REPORT ON
THE NH-57 AND RAILWAY BRIDGE OVER
THE KOSI RIVER AT NIRMALI

THE NH-57 AND RAILWAY BRIDGE OVER THE RIVER KOSI AT NIRMALI

SYNOPSIS

Photo 1. The River Kosi Discharge Gage Reading at Bhimnagar Barrage on 17.08 2010 at 1200 Hrs.

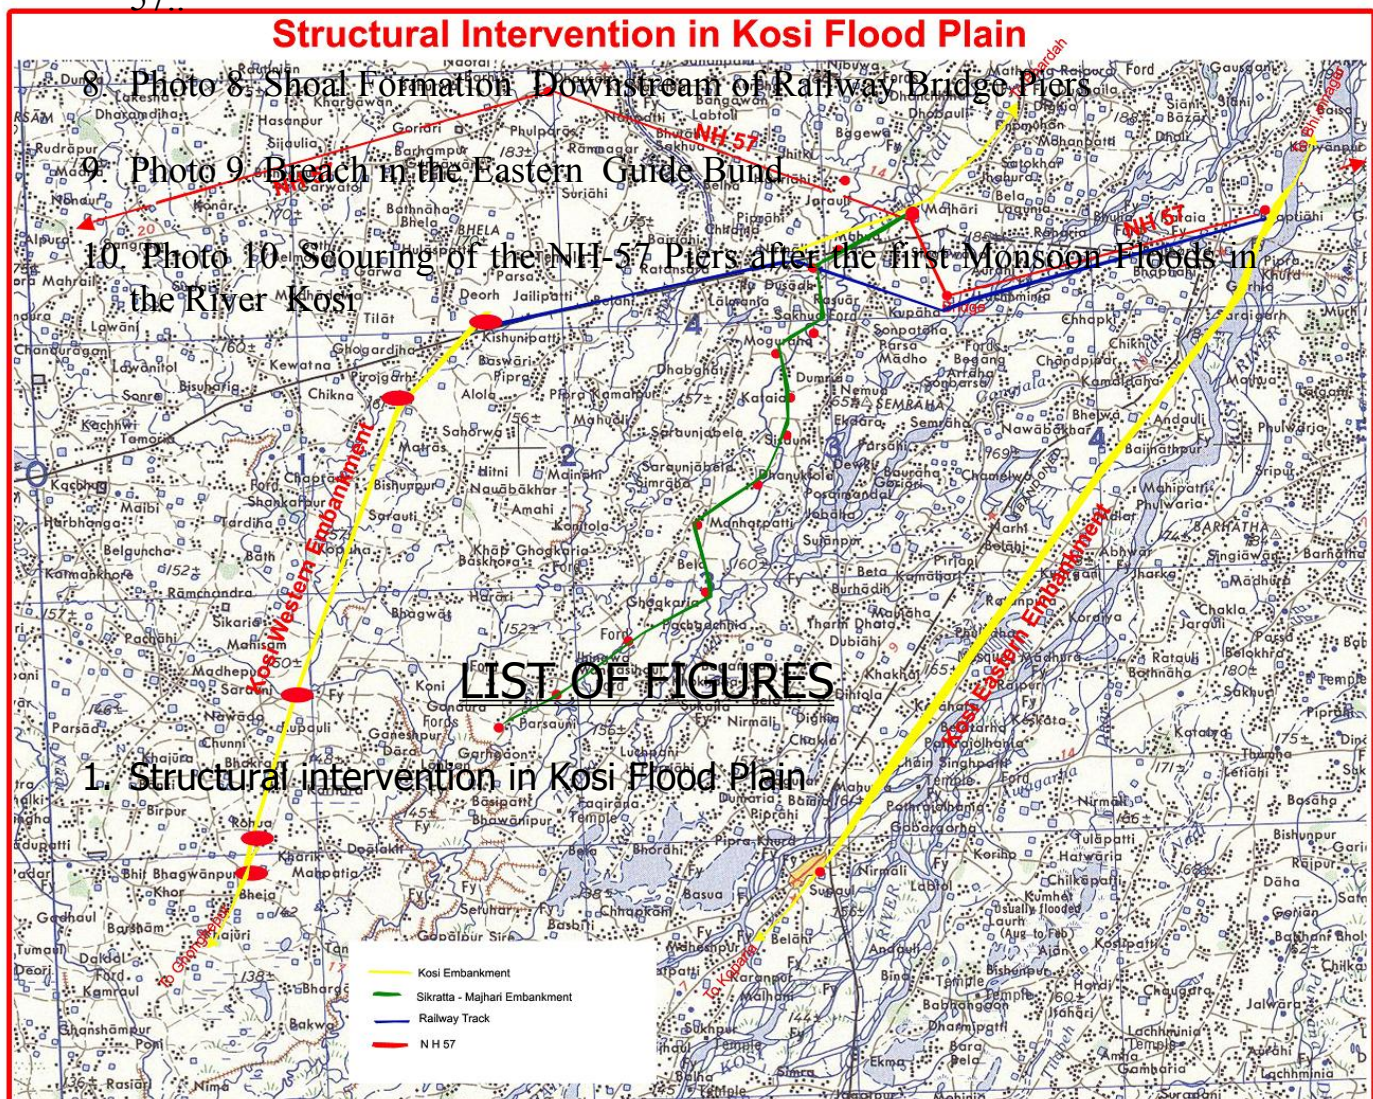
prediction. At the river discharge of 1 50 600 Cusec (4265 cumecs), recorded on the 17th August 2010 at 12:00 Hrs at the Kosi Barrage at Bhimnagar (photo 1&2), the afflux was over 3m and back water spread far upstream (photos 3&4). This caused heavy flooding of human habitations, deposition of sand in arable lands, and destruction of private and public properties (Photo 5, 6). Over thirty school buildings were rendered dysfunctional. The afflux bund cum protection embankment of the NH-57 on the left, which had blocked the flow of two secondary channels, breached downstream of Bhaptiyahi and was washed away in to the swirling current (Photo 7). This breach was enlarged to a length of nearly three kilometers. All attempts to plug this breach and stop the erosion were in vain till the end of monsoon. As a consequence of the breach of the afflux cum protection embankment, nearly four Km long eastern segment of the approach road of the NH 57 Bridge also got washed off into the River Kosi. This segment of the NH-57, constructed in the flood plains of the Kosi, had been washed away in the last monsoon too. Even after drainage of flood water downstream through this breach, the water level rose more than three meters high in the villages, which were located 15Km upstream of the bridge. One such example is the village Siani, 15 km away from the Bridge (Fig1). Here the rising backwater compelled inhabitants to leave their houses, carrying their thatched roofs on boats. The afflux level of upstream water, caused after construction of the afflux cum protection bunds on either side of the main channel was four to five times higher than the estimates made by the experts. As a result of this, water had entered the dwellings of the people, forcing their mass migration to higher places.

Photo 7. Breach in the Left Afflux cum Protection Embankment of the NH 57..

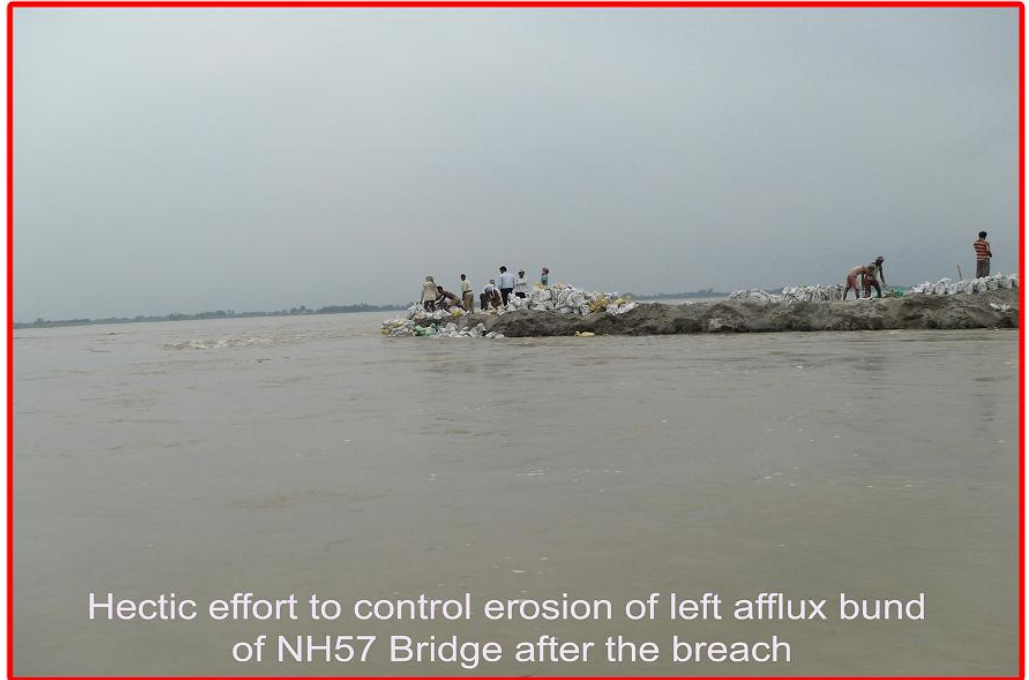
The Bridge site selection, alignment, Hydraulic Design of waterway and River Appurtenances like the common Guide bunds, afflux cum protection embankments, physical model tests and computer model studies were done by CWPRS, Pune under the guidance of a Technical Committee under the Chairmanship of DG (RD & AS), Ministry of Road Transport and Highways/ Member (Technical), NHAI New Delhi. The Govt. of Bihar was represented in this Committee by Chief Engineer, Central Design Organization, Water Resources Department. Based on the tests and the studies conducted by CWPRS the waterway for both the Bridges were fixed as 1853 m and spread of Backwater and level of afflux upstream were estimated as 8 km and 1.35 m respectively at the Design Discharge of 22 375 cumecs (7.9 lac cusecs). However after completion of the Guide Bunds and Afflux cum Protection Embankments in the Kosi Flood Plains, and at about twenty percent of the Design Discharge of the River Kosi in the monsoon floods of the year 2010, the spread of the Backwater and Level of the Afflux far exceeded the predictions made by the CWPRS. This resulted in inundation of large number of villages upstream of the Bridge, affecting lives of nearly fifty thousand people. The eastern Afflux cum Protection Embankment, Guide Bunds and the NH-57 Bridge approach segment suffered breaches.
